DISCOVER ENERGY SYSTEMS

TECHNICAL SERVICE BULLETIN

Two Inverters on One AES 210HV

CSB Number	855-0027 REV A
Date	June 1, 2026

Figure 1. Supported and unsupported Sol-Ark or Solis inverter to AES 210HV configurations

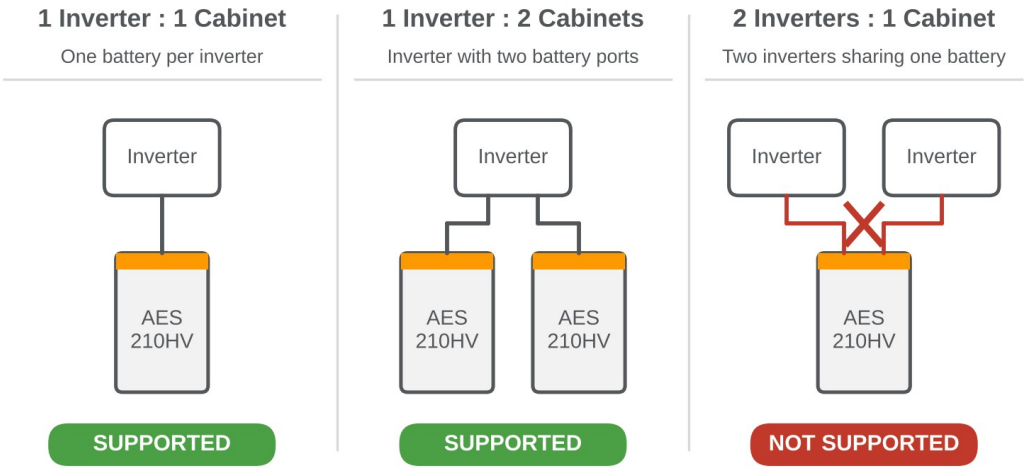
Effective June 1, 2026, Discover Energy Systems no longer supports AES 210HV systems where **two Sol-Ark or Solis hybrid inverters connect to one cabinet** (a 2:1 inverter to cabinet configuration).

Sol-Ark has identified a hardware limitation associated with connecting two of its hybrid inverters to a single battery cabinet. Neither Sol-Ark nor Solis approves or warrants configurations in which two hybrid inverters share a single battery cabinet. Accordingly, Discover Energy Systems no longer supports this system configuration.

Earlier Discover integration guides and collateral listed two inverters on one cabinet as a standard configuration. That content is withdrawn and is superseded by this bulletin.

Configuration	Description	Status
1 inverter : 1 cabinet	One inverter connected to one AES 210HV through one LYNK II Gateway.	**Supported**
1 inverter : 2 cabinets	One inverter with two battery ports. Each AES 210HV connects to its own port with its own LYNK II Gateway.	**Supported**
2 inverters : 1 cabinet	Two inverters sharing one AES 210HV.	**Not supported**
Mixed ratios	1:1 and 1:2 sets combined in the same system.	**Not supported**

Scale larger systems by paralleling complete inverter and cabinet sets on the AC bus, within the inverter manufacturer's parallel limits. Keep the same ratio across every set in the system.
